LICENSEE: Mississippi Power & Light Company (MP&L)
FACILITY: Grand Gulf Nuclear Station, Unit 1
SUBJECT: SUMMARY OF MAY 7, 1986 MEETING REGARDING SPENT FUEL
POOL COOLING

RESPONSE TO THE NRC CONCERNS ABOUT THE SPENT FUEL POOL BULK
TEMPERATURE ANALYSIS FOR THE HIGH DENSITY SPENT FUEL RACKS

FIGURE 1

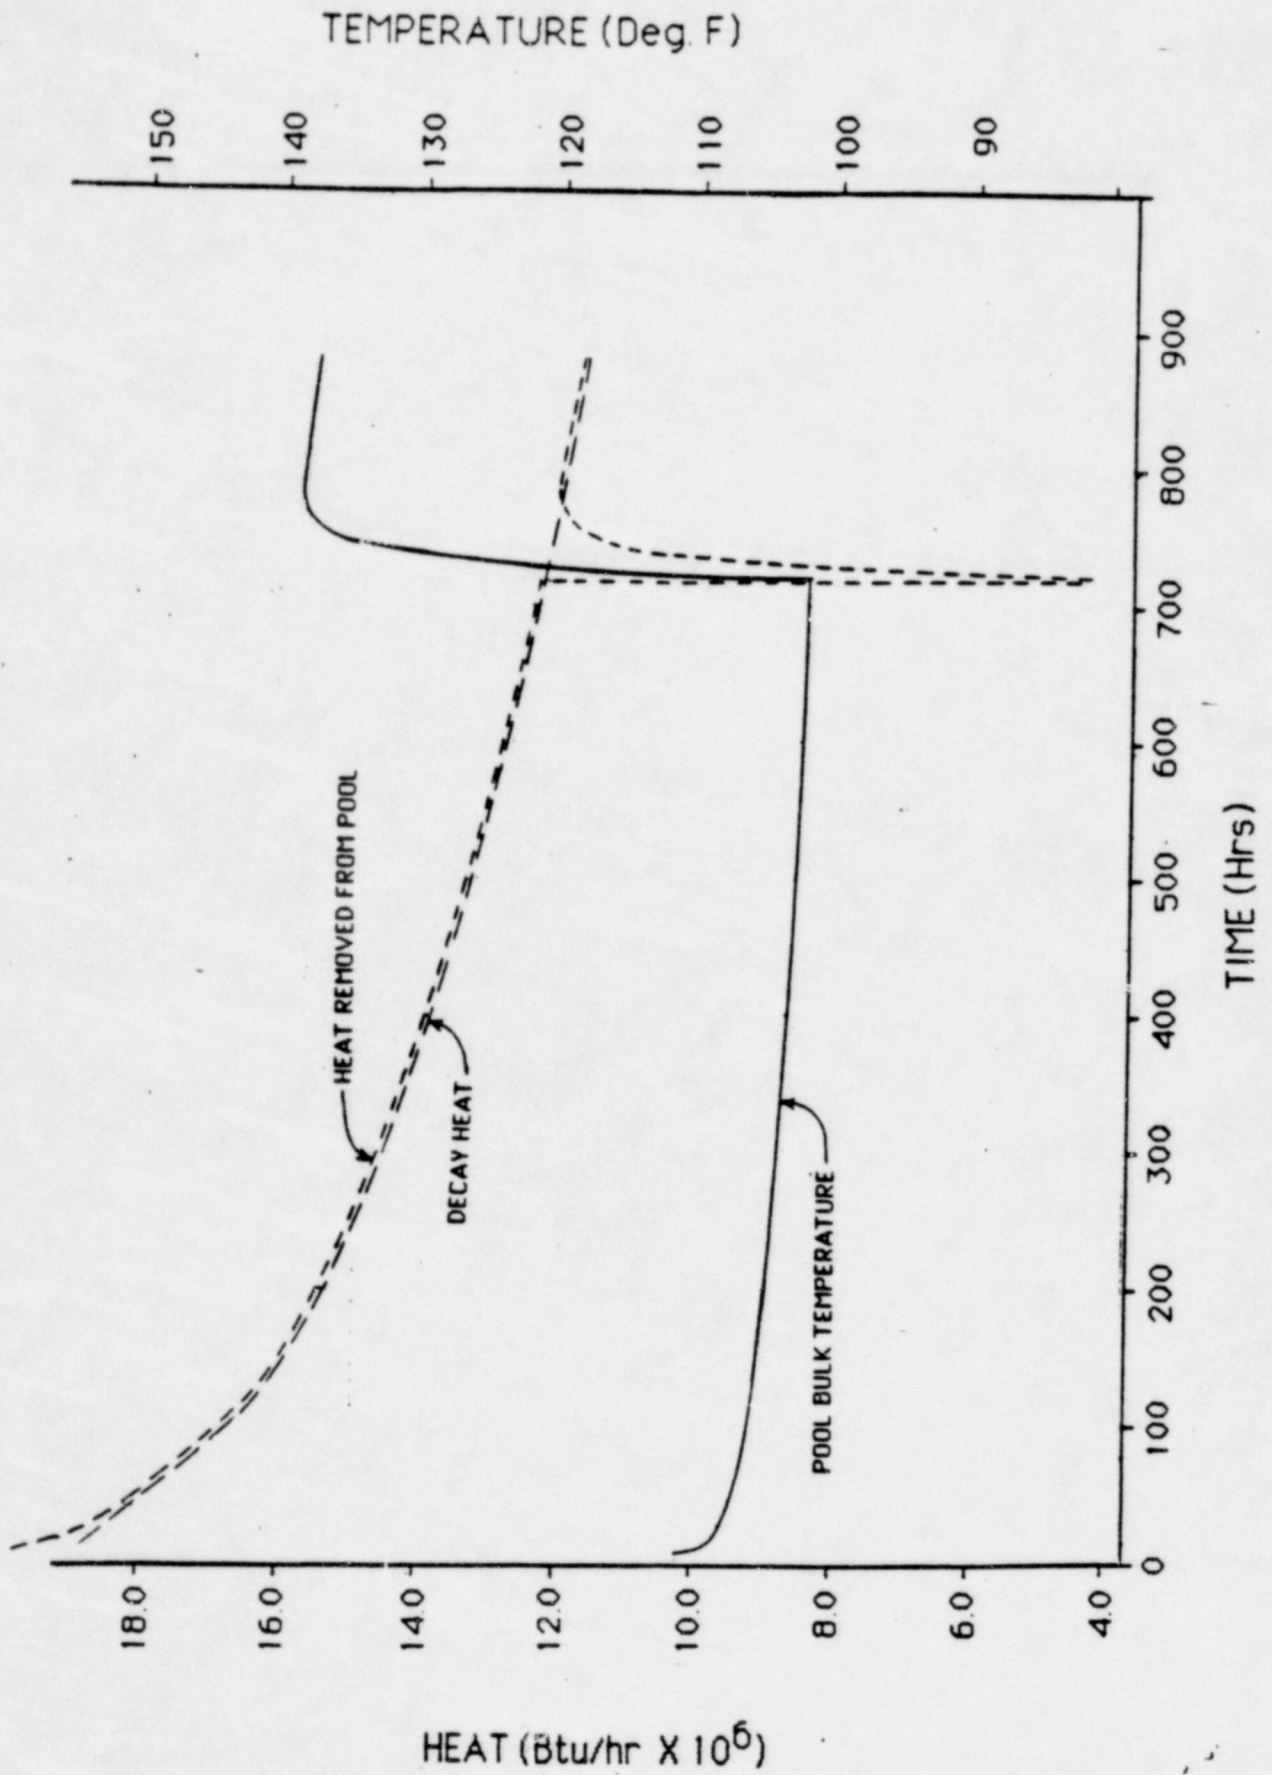
The NRC requested that the Pool Bulk Temperature Analysis for the high density spent fuel storage racks be reanalyzed assuming the failure of a spent fuel pool heat exchanger train at a time when RHR was not available to supplement fuel pool cooling. The NRC also expressed concern that the heat loads for the pool bulk temperature analysis were not correctly calculated.

The analysis of the spent fuel pool bulk temperatures (Figure 1) shows that the heat removed by the cooling systems varies with pool temperature, since the heat transfer rate of the heat exchanger is increased with the increase in the temperature difference between the pool water and the cooling water. The maximum pool bulk temperature is reached when the heat removed from the pool equals the decay heat load of the spent fuel. The actual maximum pool bulk temperature calculated was 140.04°F.

As a conservatism to the pool bulk temperature analysis, the number of fuel assemblies which can be off-loaded to the spent fuel pool will be limited to the number projected through the ninth refueling outage (which is 2096 assemblies). This limit will be observed until equipment modifications have been made which will enable the cooling systems to keep the temperature associated with greater amounts of spent fuel below 140°F. Design changes for the modifications to the cooling systems will be defined before the third refueling outage and implemented prior to restart after the fifth refueling outage.
